**PROPELLER SHAFT  
AND UNIVERSAL  
JOINTS**

PROPELLER SHAFT FRONT JOINT OIL SEAL UG.2995.

PROPELLOR SHAFT FRONT UNIVERSAL COUPLING

PROPELLER SHAFT UNIVERSAL JOINT -  
FRONT COUPLING.

Fig. 1.

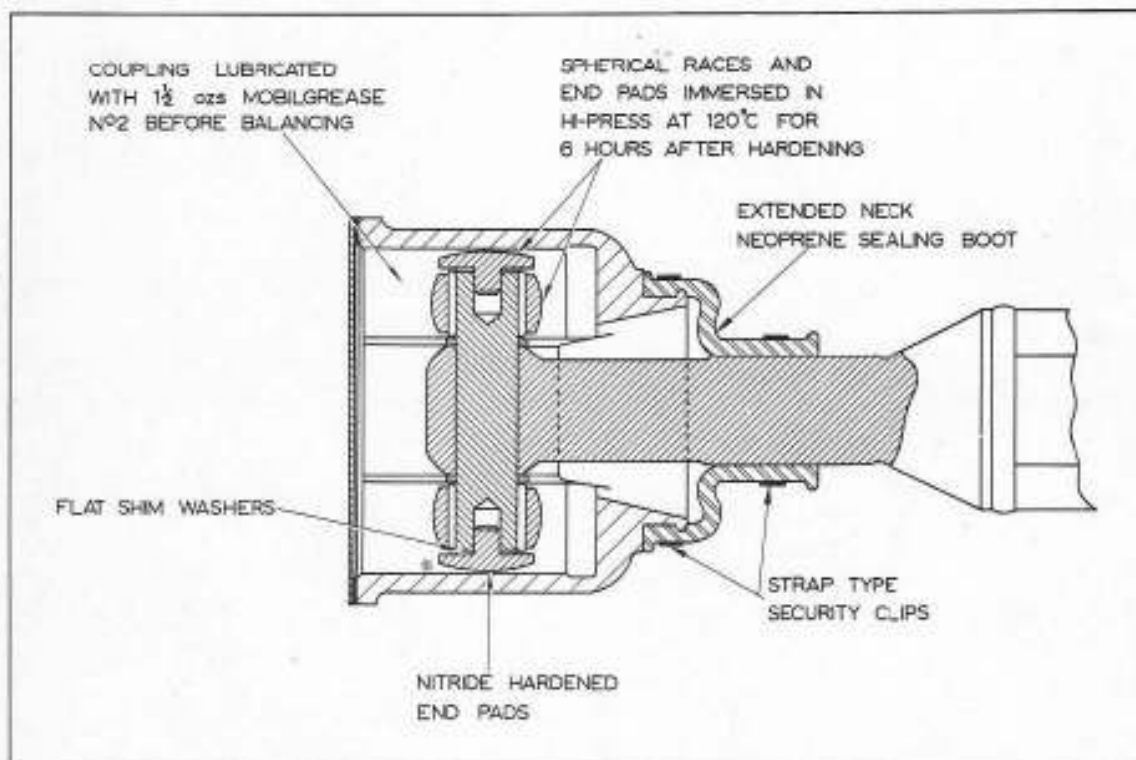
Fig. 1. shows at a glance the modifications incorporated on the front universal coupling used on 'S' Type cars in current production.

The possibility of variation in dynamic balance occurring due to compression of the wavy washers fitted between the end pads and the cross-pin, has been countered by deleting the wavy washers and substituting flat shim washers. These are selected to give zero clearance of the cross-pin and end pads in the coupling lobes.

As heat is necessary to obtain the full benefit of using an Extreme Pressure lubricant, the spherical races and end pads are now immersed in Hi-Press Oil at 120 °C for 6 hours after hardening. This pre-treatment is considered preferable to relying on local heat generation in service and should prevent any fretting occurring at the contact areas of the spherical races and end pads. In addition, a change in the material specification from a case hardening to a nitriding steel has been made for the end pads.

As an insurance against the boot being damaged in this manner, the clip has been repositioned further away from the seal face by extending the neck of the boot 0.575 ins. together with a corresponding increase in width of the sealing land on the shaft stem. The Part No. of this long neck sealing boot is UG. 3553, and it is permissible to use this latest seal as a service replacement when overhauling shaft assemblies originally fitted with the short neck sealing boot.

Strap type security clips Part Nos. UG. 3554/5 have been adopted with this long neck seal, the shorter clip being positioned as near as possible to the rear of the neck. These clips are of a more compact design and by the nature of their constructions exert an evenly distributed radial clamping pressure.
